Product Change Notice (PCN)

PCN Number: PCN-0450780R-01

Product(s) Affected: MD-PL100 series (part numbers MD-30PL100, MD-40PL100, MD-50PL100, MD-60PL100, MD-80PL100).

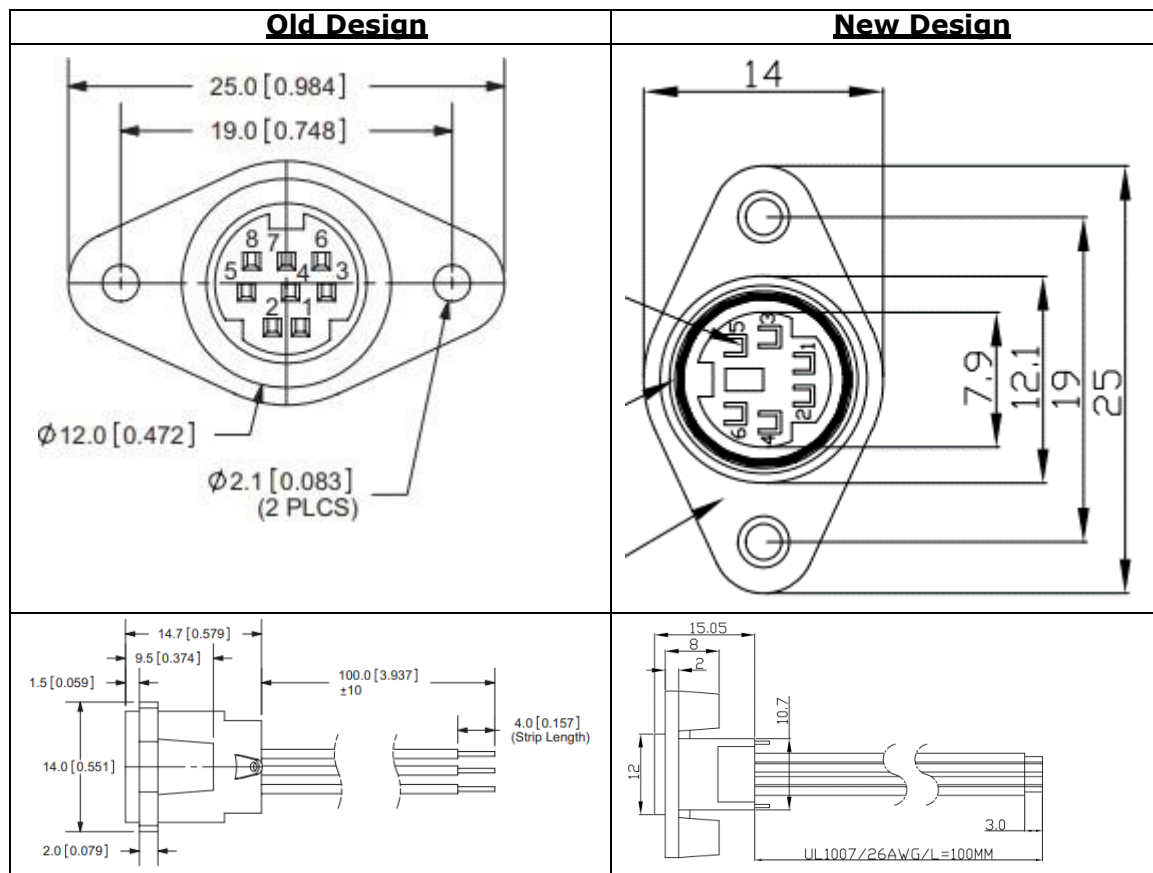
Reason(s) for Change: Manufacturing build location change

Description of Change: minor housing changes and materials changes as shown below.

Old design materials

MATERIAL	PLATING
earth terminal	brass	tin
contact terminals (1~8)	phosphor bronze	tin
wire	AWG #26	
plastic	PBT

New design materials

MATERIAL	PLATING
body	PBT (UL94V-0)	
earth terminal	phosphor bronze	nickel
contact terminals	phosphor bronze	tin
wire	UL 1007/AWG #26
